CITY OF MEXICO BEACH
WATER TANK AERATION SYSTEM

**ADDENDUM NO. 3
REQUESTS FOR INFORMATION**

Issued March 06, 2025

FRONT ELEVATION AERATION SYSTEM

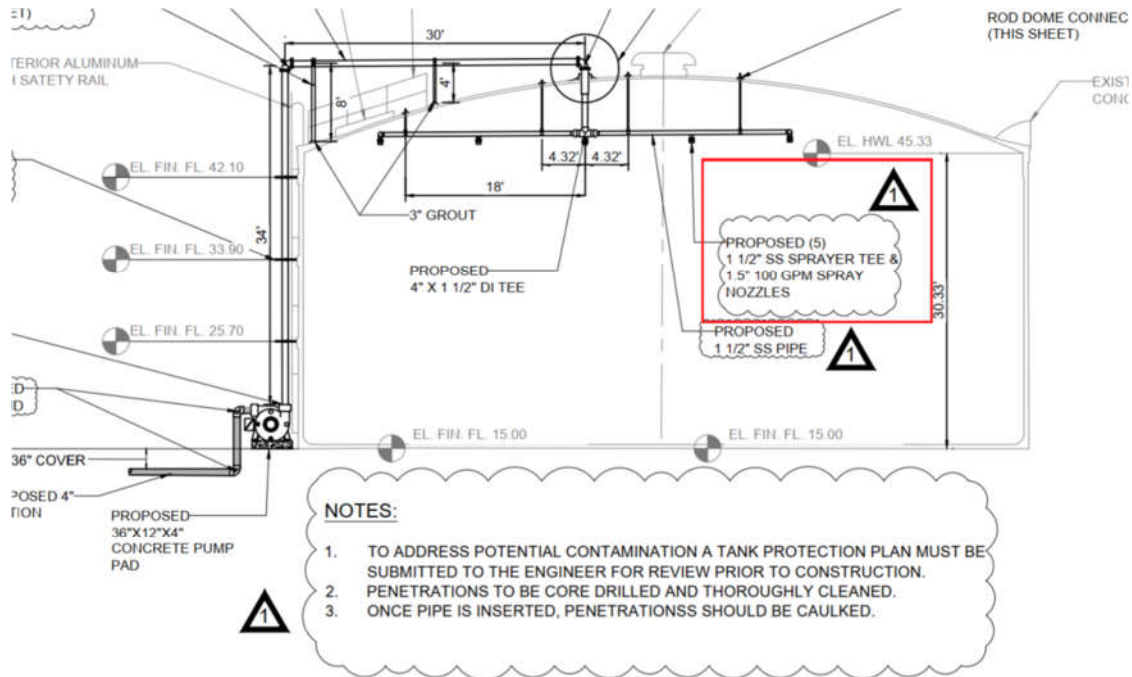
3. For clarification, the Bid Form has been modified (Attachment A) to list the (5) 1 1/2" Stainless Steel Sprayer Tees and (5) 1 1/2" 100 GPM Spray Nozzles separately. See image below (next page) for reference.
